<u>MEETING</u> CHIPPING BARNET AREA COMMITTEE
<u>DATE AND TIME</u> MONDAY 19TH FEBRUARY, 2018 AT 7.00 PM
<u>VENUE</u> HENDON TOWN HALL. NW4 4BG

Title	Review of the Barnet Hospital Area Statutory Parking Consultation
Report of	Strategic Director for Environment
Wards	Underhill and High Barnet
Status	Public
Enclosures	<p>Appendix A –</p> <p>Drawing No. SCR191-2a - Proposed CPZ - Granville Road and Argyle Road EN5 (revised)</p> <p>Drawing No.SCR191-3a - Proposed CPZ – Elmbank Avenue, Garthland Drive, Vyse Close, Wellhouse Lane and Wellside Close EN5 (revised)</p> <p>Drawing No.SCR191 – 4a Proposed CPZ - Lingholm Way, Lexington Way and Sutton Crescent EN5 (revised)</p> <p>Drawing No.SCR191-5 - Galley Lane and Barnet Road</p> <p>Drawing No.SCR191-6 - Trinder Road, Well Road and Well Approach</p> <p>Drawing No.SCR191-7 - Bells Hill and Spring Close , St Stephen Road and Redwood Way</p> <p>Drawing No.SCR191-8 - Aitken Road, Denton Close, North Close, Escot Way and Endersby Road</p> <p>Drawing No.SCR191-9 - Kings Road and Cavendish Road</p> <p>Drawing No.SCR191-10 - Kings Road and Grimsdyke Road</p> <p>Drawing No. SCR191-11 - Bells Hill and Dellors Close</p> <p>Drawing No.SCR191-12 and SC

DRAWING NO:
SCR191-4a

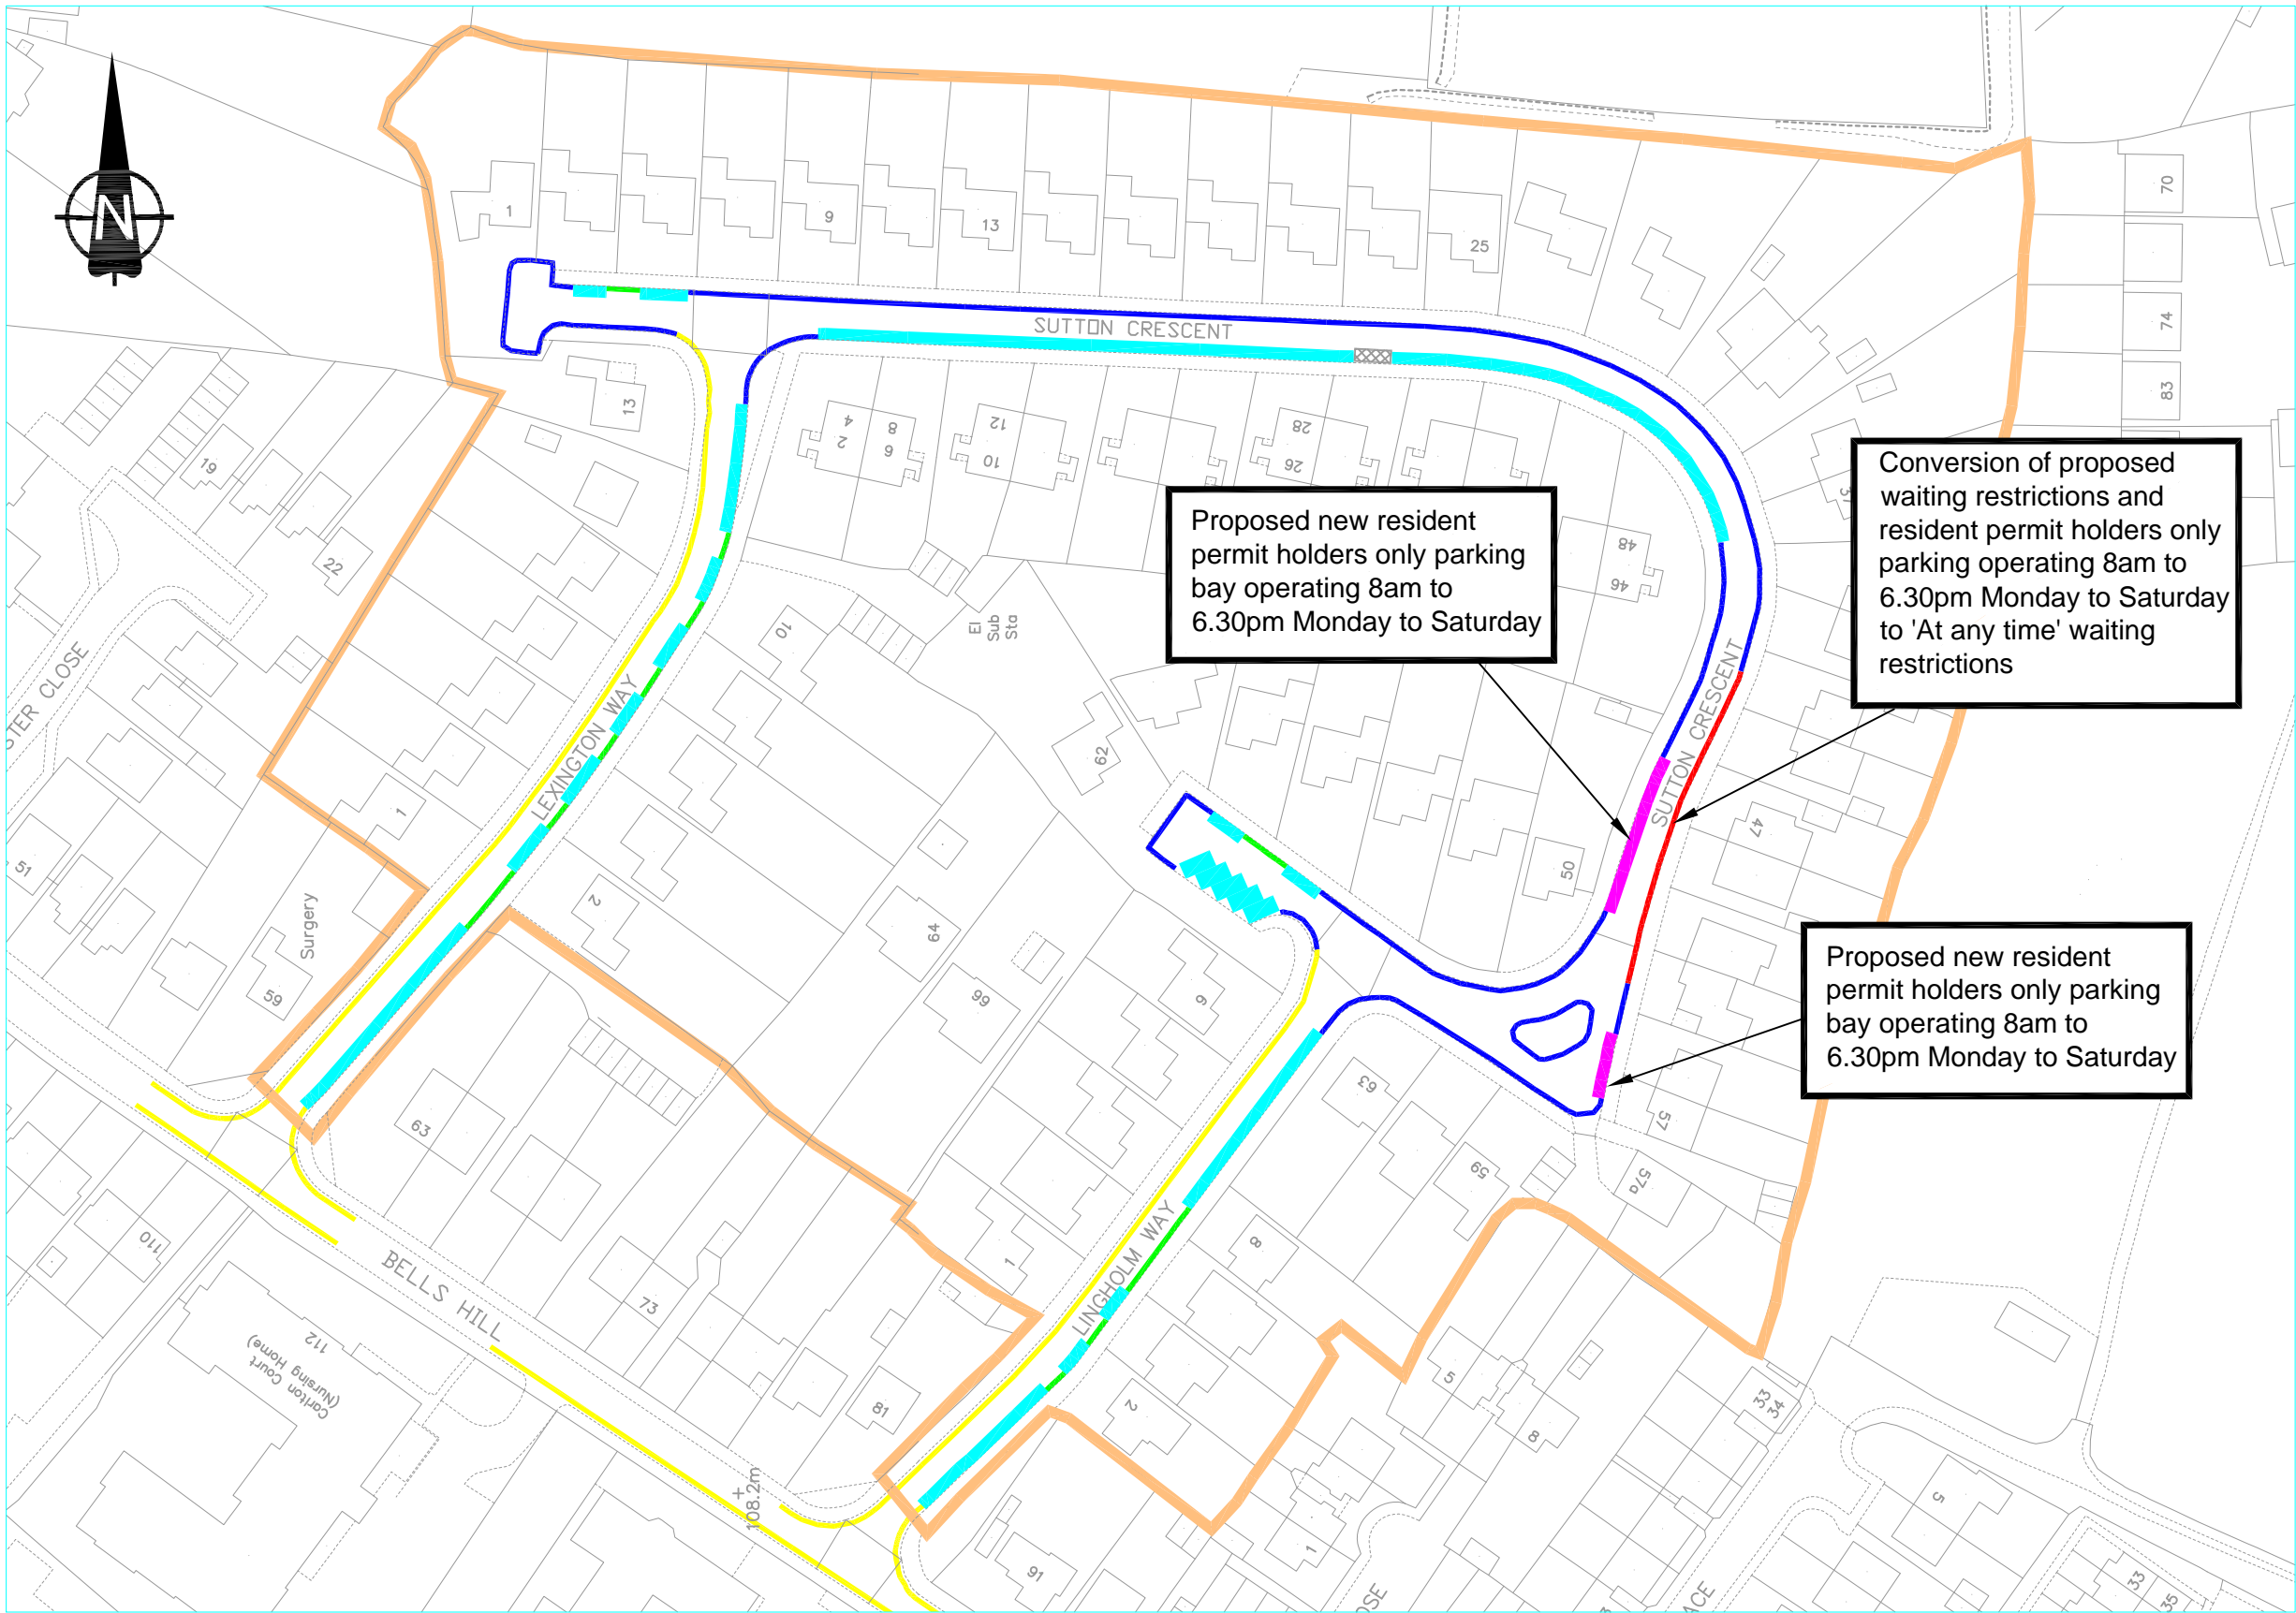
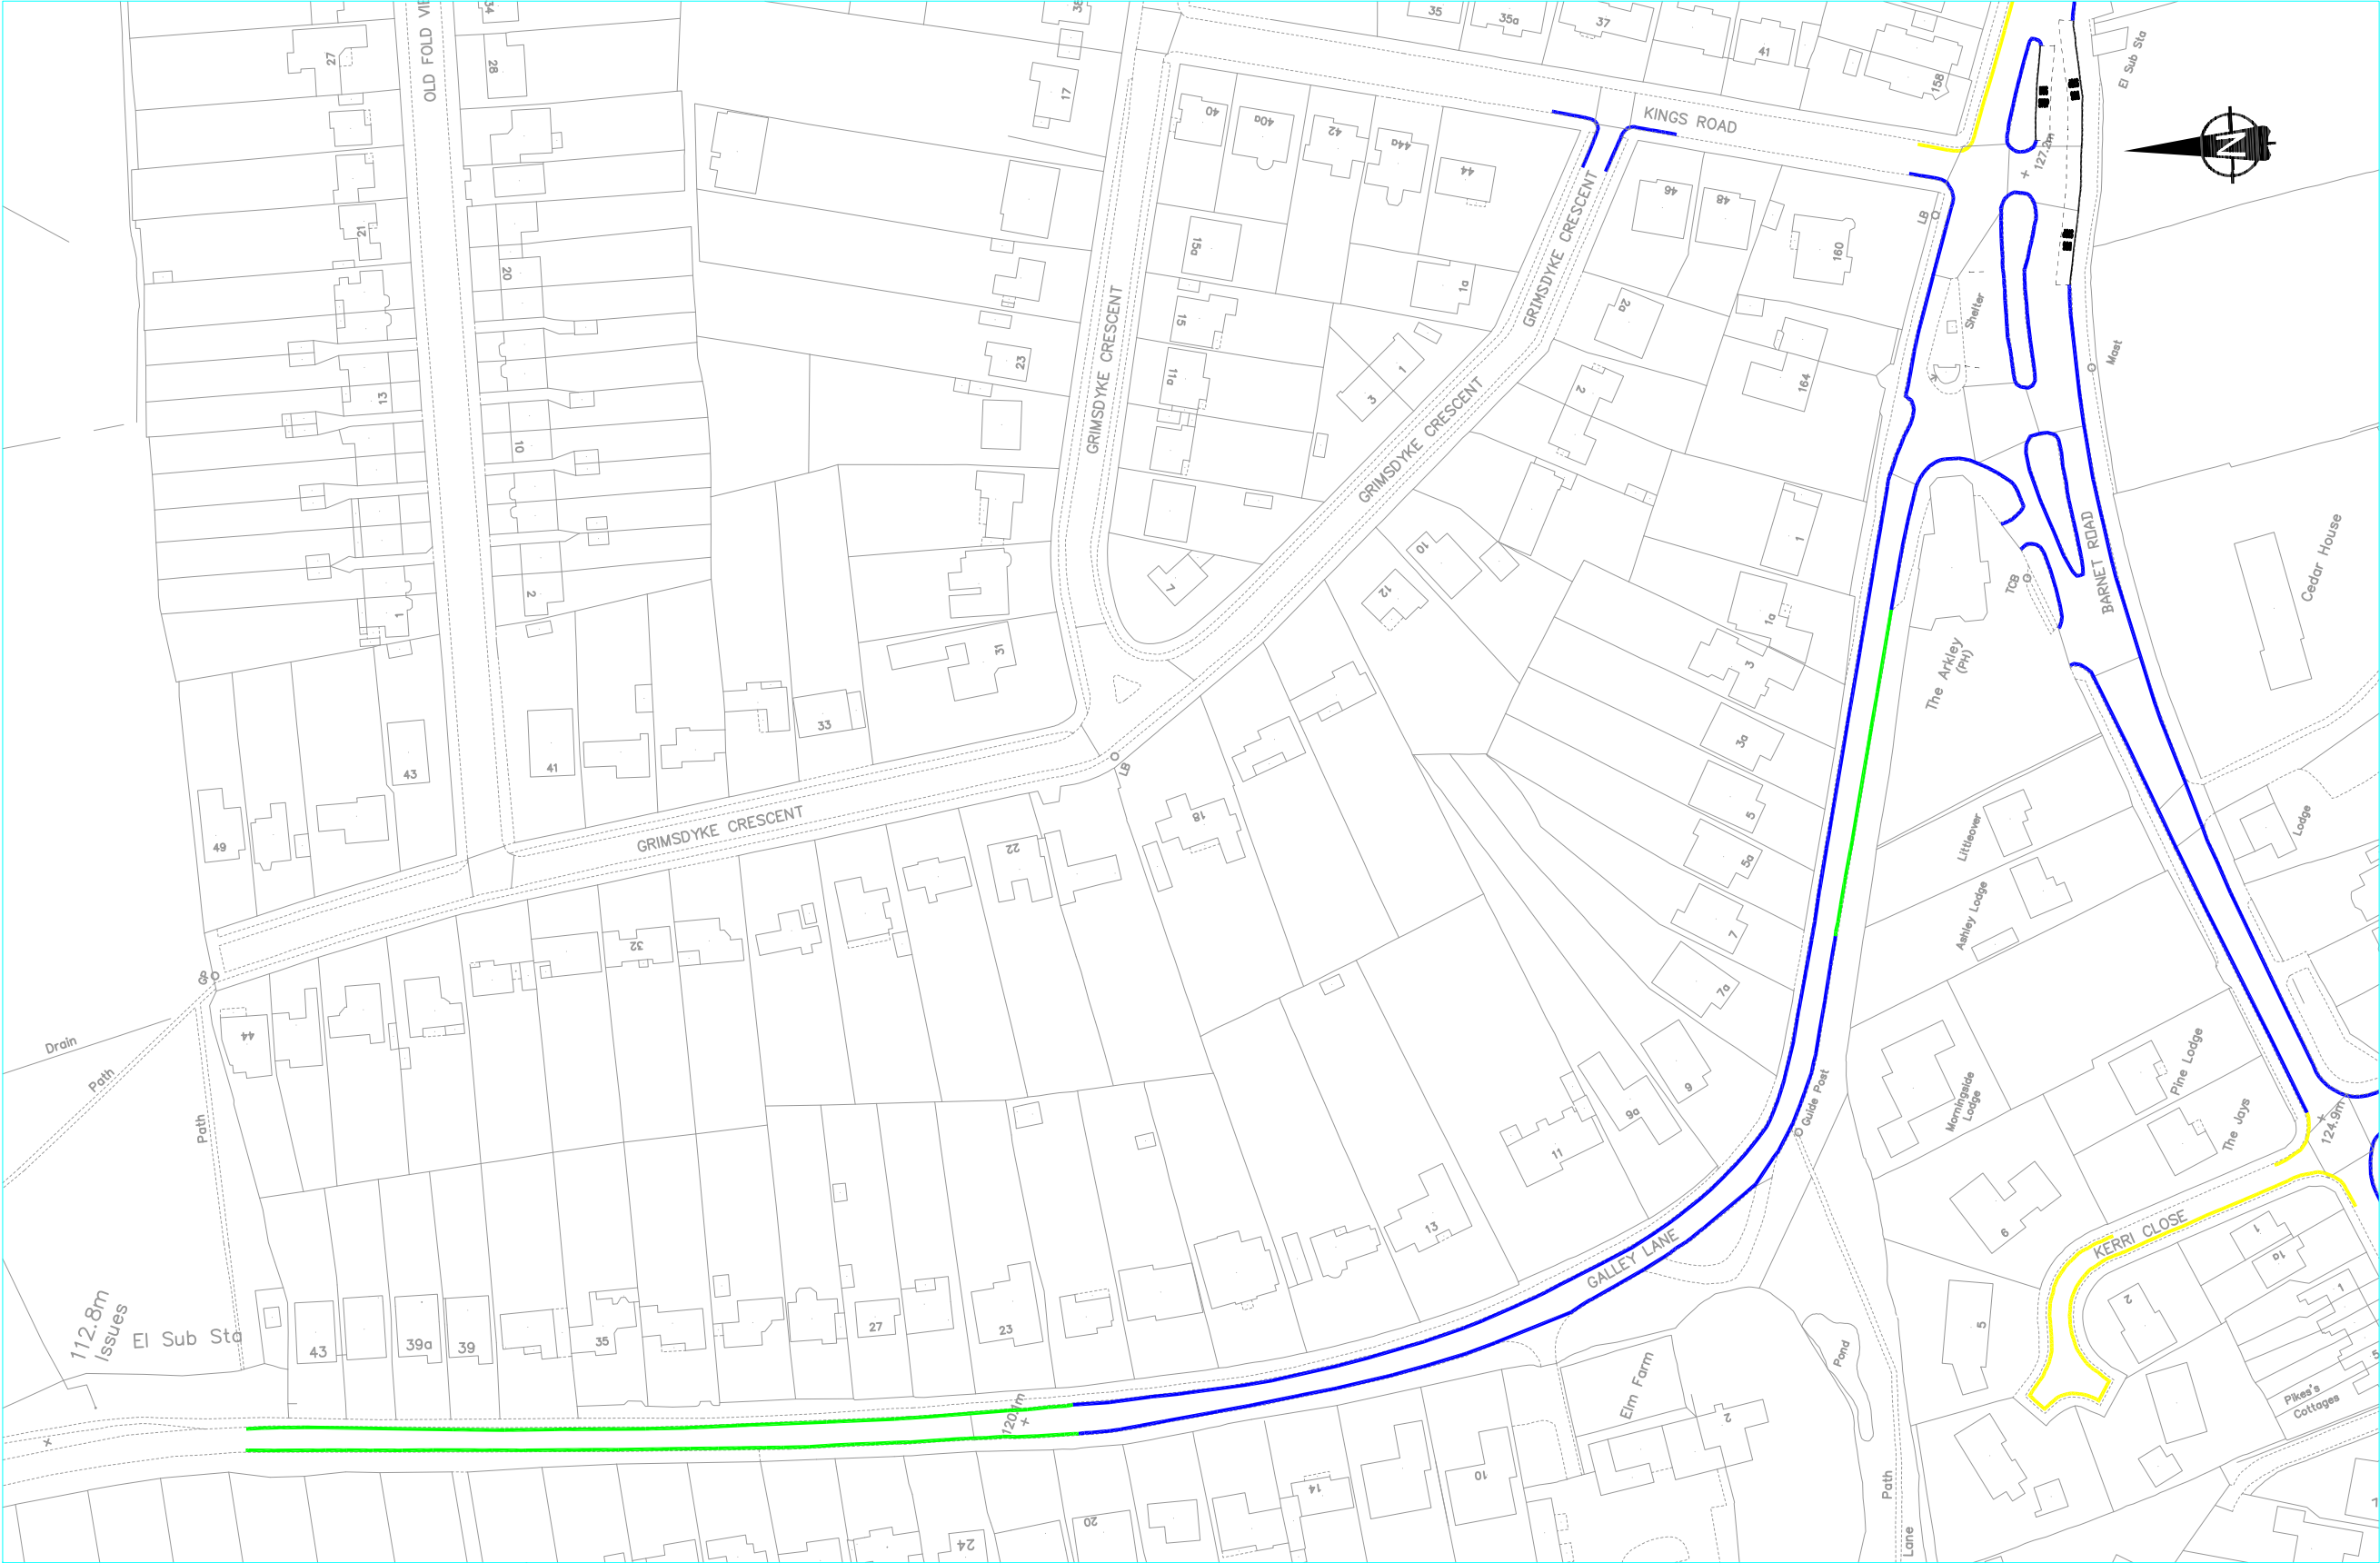
- Two residents of Sutton Crescent requested for the proposed resident permit holders only parking bays outside No.43 and No.45 Sutton Crescent , outside No.51 and No.53 Sutton Crescent and outside No.46 Sutton Crescent converted to “At any time” waiting restrictions which

- Correspondence was also received from two residents of Sutton Crescent requesting for the proposed “At any time” waiting restriction outside No.55 and No.53 Sutton Crescent, and also outside No.61 Sutton Crescent to be converted resident permit holders only parking bays.
- 5 residents within the proposed CPZ were concerned about the length of the proposed operational hours and the CPZ operating on a Saturday.

- 2.18 Due to the concern from residents in Bells Hill, it is considered that the residents of Nos. 91 to 113 Bells Hill should be allowed eligibility to obtain permits and vouchers which would enable them to park in the CPZ.
- 2.19 Furthermore, it is considered that there should be parking bays removed and additional bays provided on Sutton Crescent as shown on plan SCR191-4a.
- 2.20 Therefore it is considered that the proposal should be implemented with minor modifications as outlined above as shown on plan SCR191-4a and include permit eligibility for the residents of Nos. 91 – 113 Bells Hill.

- b. That an additional parking place should be provided on Granville Road outside No.51 Granville Road – Drawing No.SCR191-2a.**
 - c. That the proposed resident parking bays on Sutton Crescent outside No. 41 and No. 43 Sutton Crescent , outside No. 47 and No. 49 Sutton Crescent and outside No. 51 and No. 53 Sutton Crescent are converted to “At any time” waiting restrictions. – Drawing No.SCR191-4a.**

- d. That the proposed “At any time” waiting restrictions at the side of No. 50 Sutton Crescent is to be converted to a resident parking bay to mitigate for the loss of parking bays as outlined in c above –Drawing No.SCR191-4a.**

- e. That an additional parking place should be provided on Sutton Crescent outside No. 55 and No.57 Sutton Crescent. – Drawing No.SCR191-4a.**
 - f. That footway parking in Vyse Close is considered as an alternative to the proposed “Past this point” parking layout.**

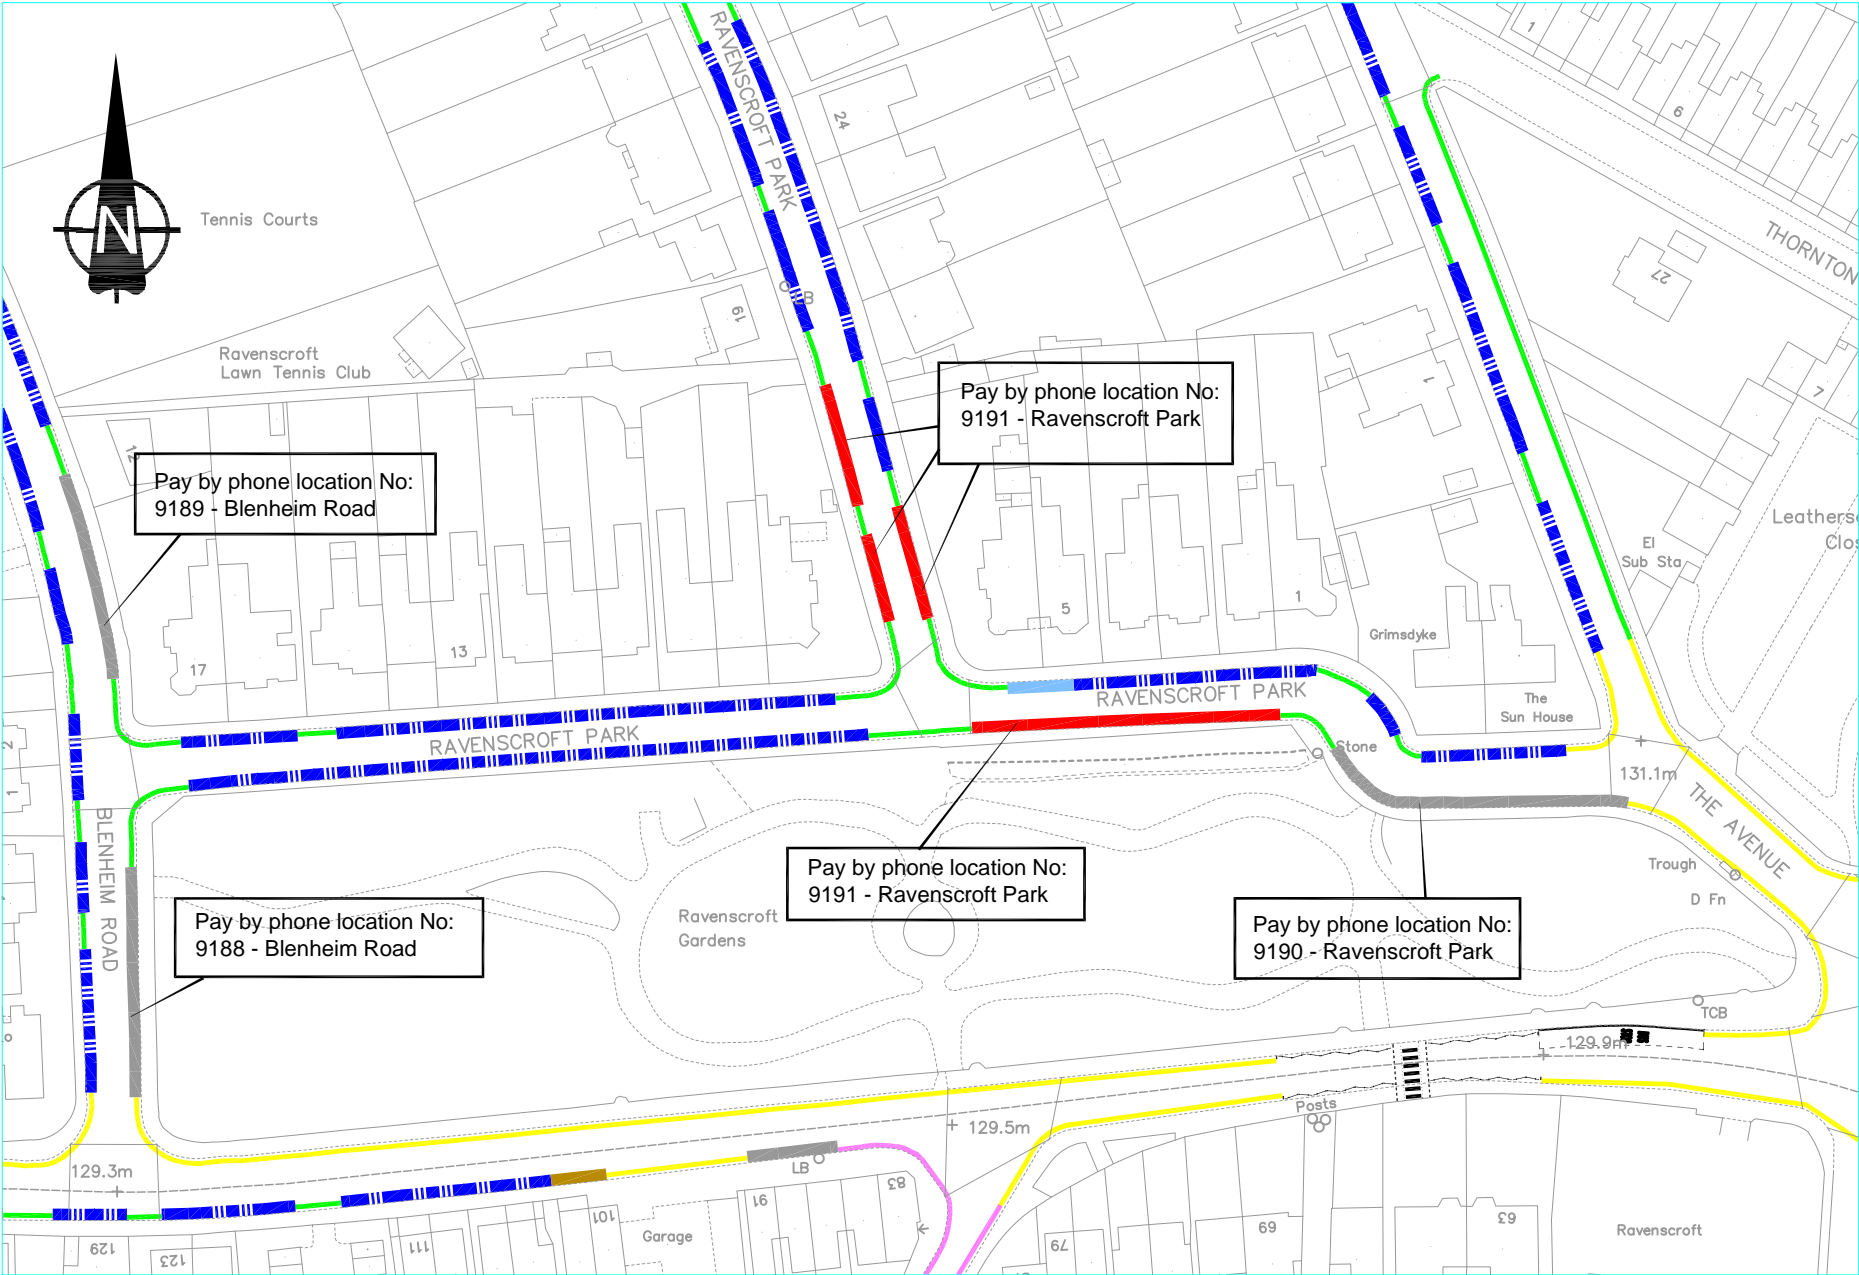
- A resident questioned why the Council is proposing waiting restrictions that would benefit the residents of Dellors Close and at the same time make things worse for the residents of Bells Hill.

- Dellors Close has plenty of useful parking which is unavailable to the residents of Bells Hill because it is a private road. Whenever the residents of Bells Hill try to park on Dellors Close some of the residents that live on that road are unpleasant to them.

- The proposed double yellow lines at junction of Dellors Close and Bells Hill will potentially take away 2 kerbside parking spaces on street on Bells Hill where it is difficult to find available parking spaces. As an alternative solution to their concerns the resident has suggested that the residents of Dellors Close should erect a mirror at their own expense which would give them a clearer view of the road. The resident also stated that they were not aware of any incidents in past and thinks that it is not fair that the residents of Bells Hill who have to park on the road should be penalised.

- 2.27 It is considered that the proposal should be implemented as shown on plan SCR191-11.
